Access Compliance Report

Public Rights-of-Way

(Curb Ramps)

Intersection ID: 16560	Main Street: OLD_PINEVILLE_RD	Cross Street: E_PETERSON_DR	Location: NE
ADA ID: 4EC8697EA295	Ramp Type: Perp	Initial Pass/Fail: Fail	Overall Compliance: No
		Severity Score: 12.5

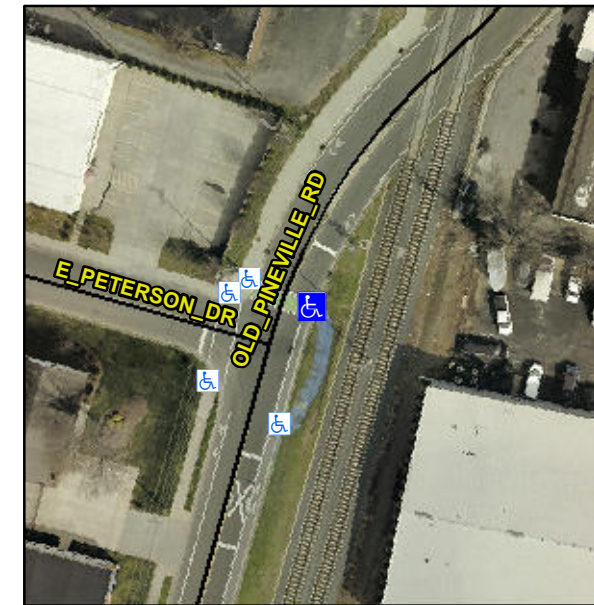
Not Found, R304.2.2

Compliance	Description	Data	Compliance	Description	Data
N/A	Ramp Length (in)	60.0	No	Ramp Slope (%)	9.3
Yes	Ramp Width (in)	96.0	Yes	Ramp XSlope (%)	1.5
N/A	Flare Type LT	N/A	N/A	Flare Type RT	N/A
N/A	Flare Slope LT (%)	N/A	N/A	Flare Slope RT (%)	N/A
N/A	Flare Traversable LT?	N/A	N/A	Flare Traversable RT?	N/A
N/A	Landing Length (in)	N/A	N/A	DWS Provided?	N/A
N/A	Landing Width (in)	N/A	N/A	DWS Contrast?	N/A
N/A	Landing Slope (%)	N/A	N/A	DWS Length (in)	N/A
N/A	Landing X Slope (%)	N/A	N/A	DWS Full Width?	N/A
N/A	Landing Curb? (Y/N)	N/A	N/A	DWS Offset (in)	N/A
N/A	Shared Landing?	N/A			
N/A	Gutter Ponding?	N/A	N/A	Gutter Slope (%)	N/A
N/A	Gutter Lip Ht (in)	N/A	N/A	Gutter X Slope (%)	N/A
N/A	Painted X Walk1?	Yes	N/A	Painted X Walk2?	N/A
	X Walk 1 Direction	To NW		X Walk 2 Direction	N/A
N/A	X Walk 1 Width (in)	96.0	N/A	X Walk 2 Width (in)	N/A
	X Walk 1 Slope (%)	3.9		X Walk 2 Slope (%)	N/A
	X Walk 1 X Slope (%)	0.9		X Walk 2 X Slope (%)	N/A

Remove & Replace Entire Ramp.
